Vermont Agency of Transportation
RECEIVED
 CK'D BY M.E.M. OK'D BY C.W.M.
 July 09, 2012
 RESUBMIT APPROVED AS NOTED
 BY C. CARLSON DATE 07-27-2012

PROJECT: VT RT 9, BRIDGE NO. 11
 TOWN OF WOODFORD, VT
 OVER WALDOOMSAC RIVER

TITLE: ABUTMENT CROSS FRAME

REFERENCE: PROJECT NO. ER BHF 010-1 (44)

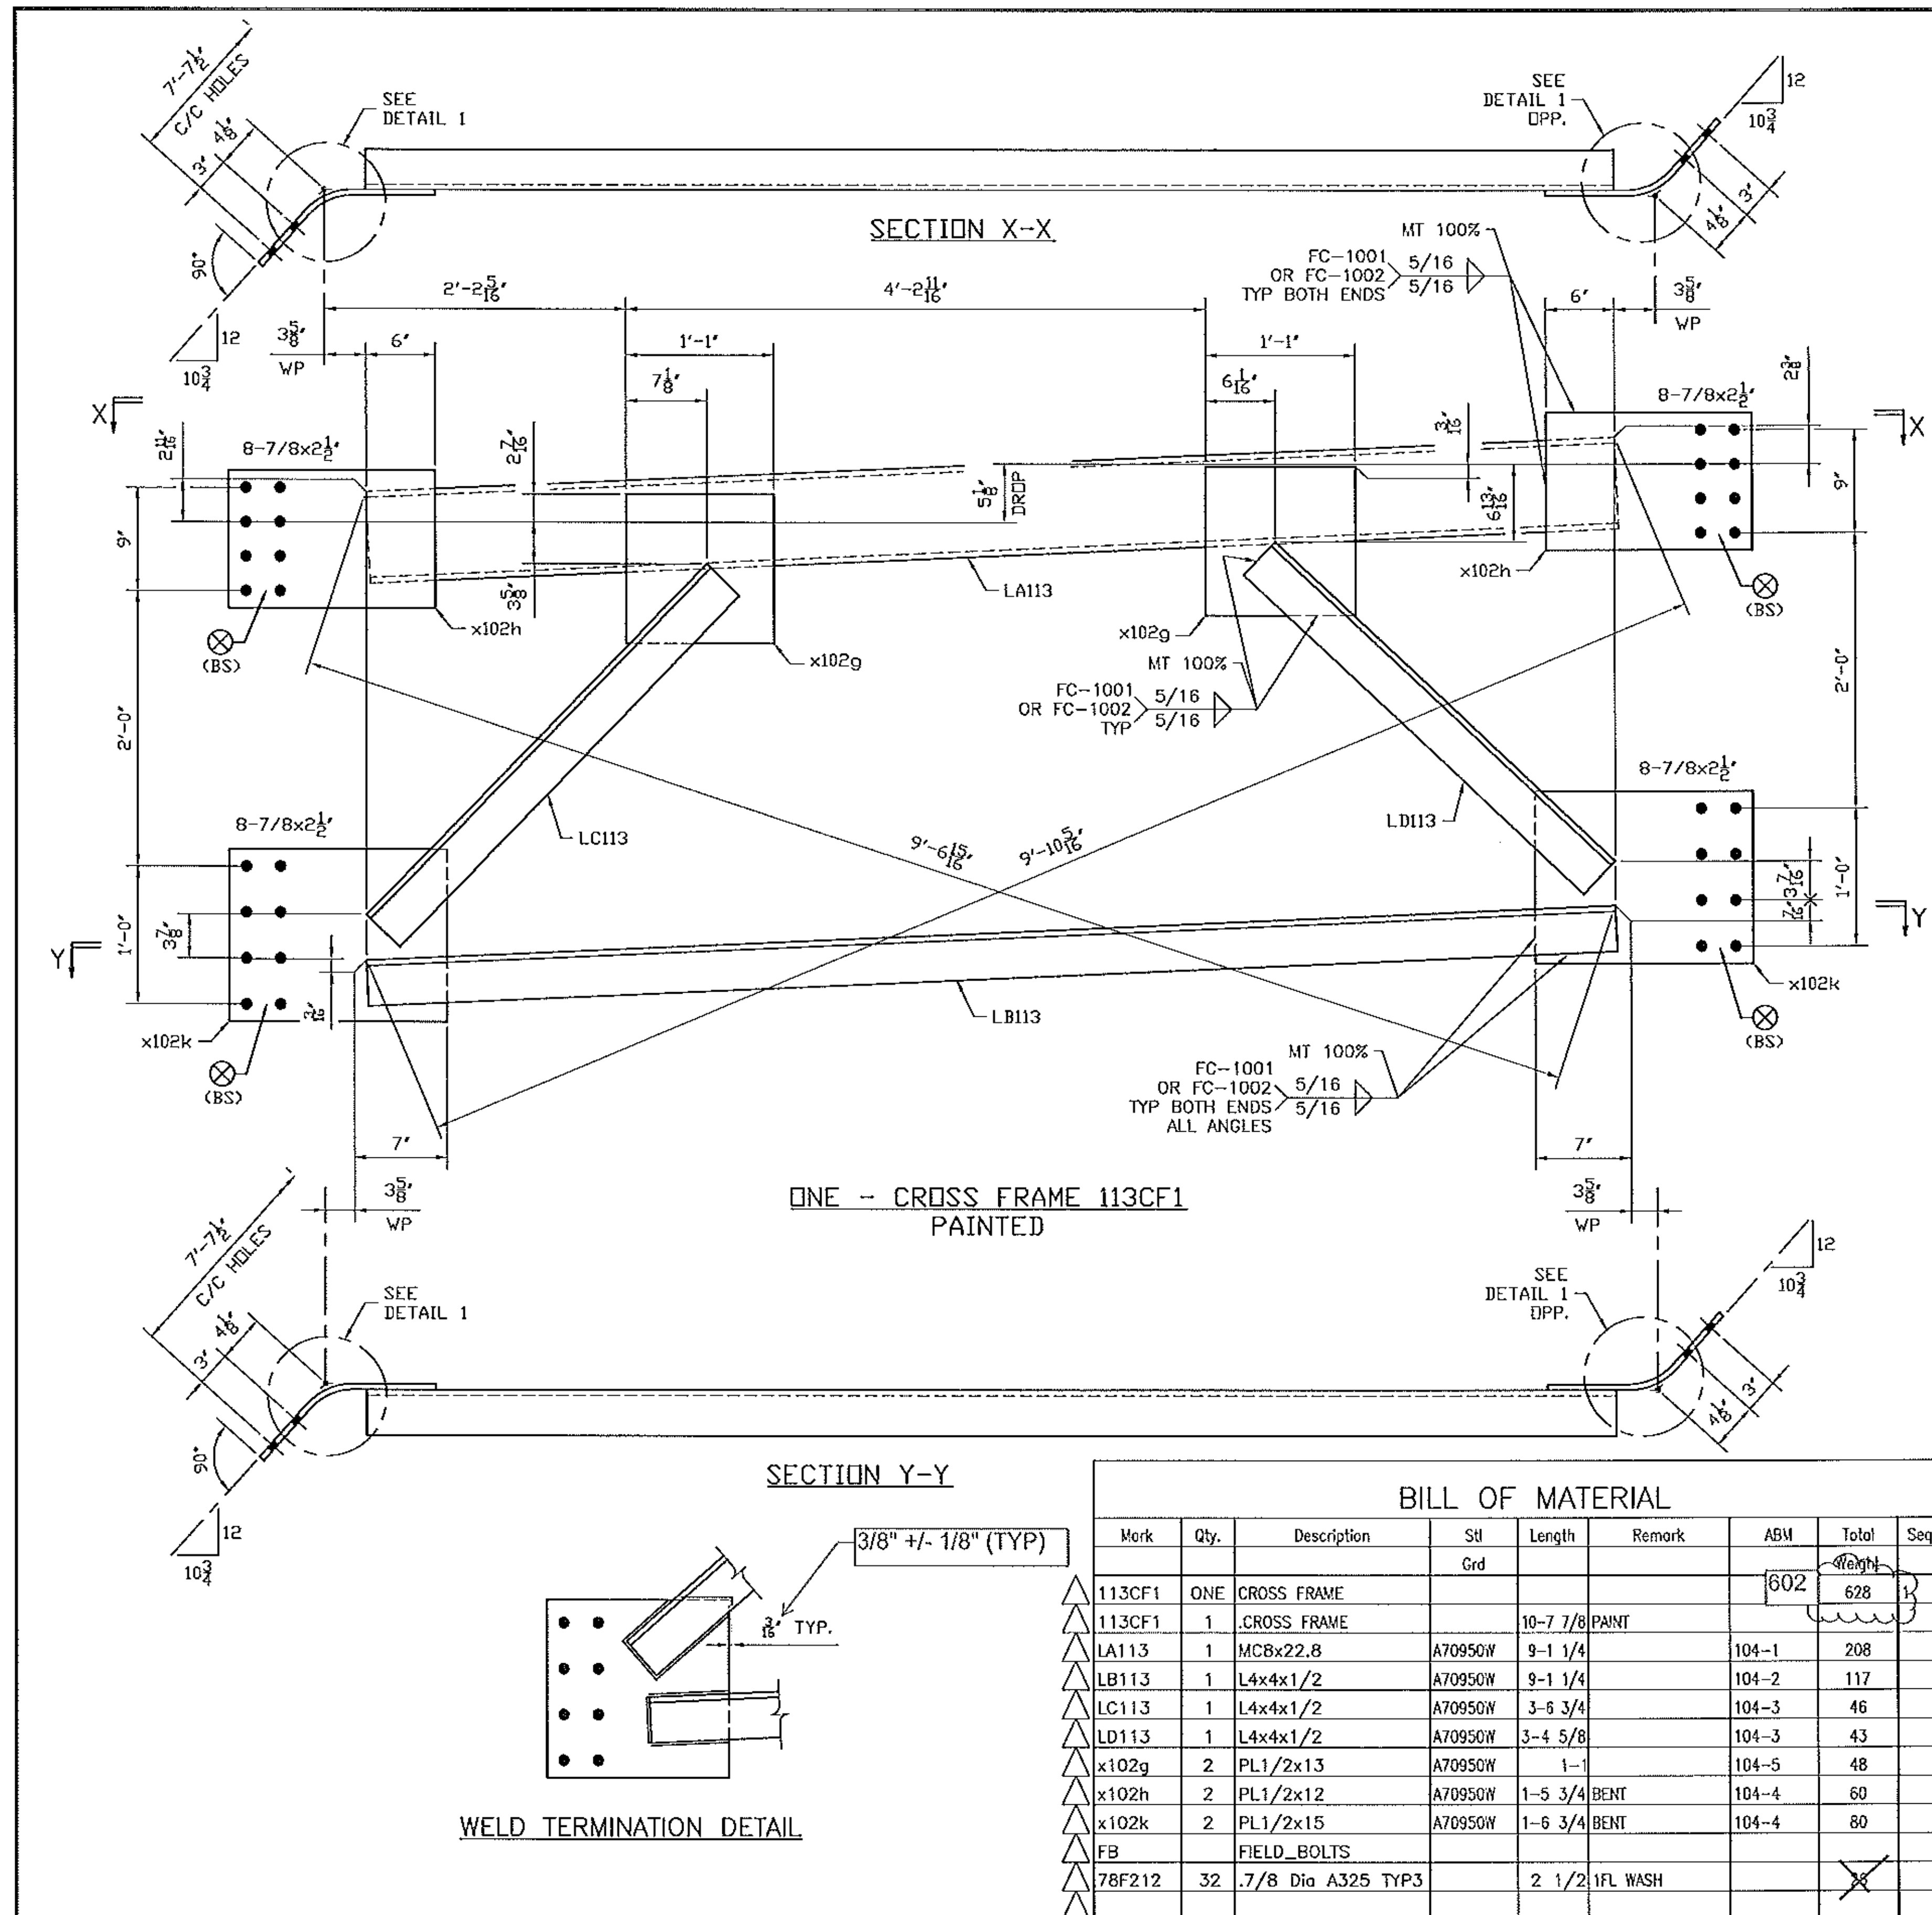
See standard specification 506.24(a)(9), no payment will be made for bolts, nuts, washers, they are considered to be incidental
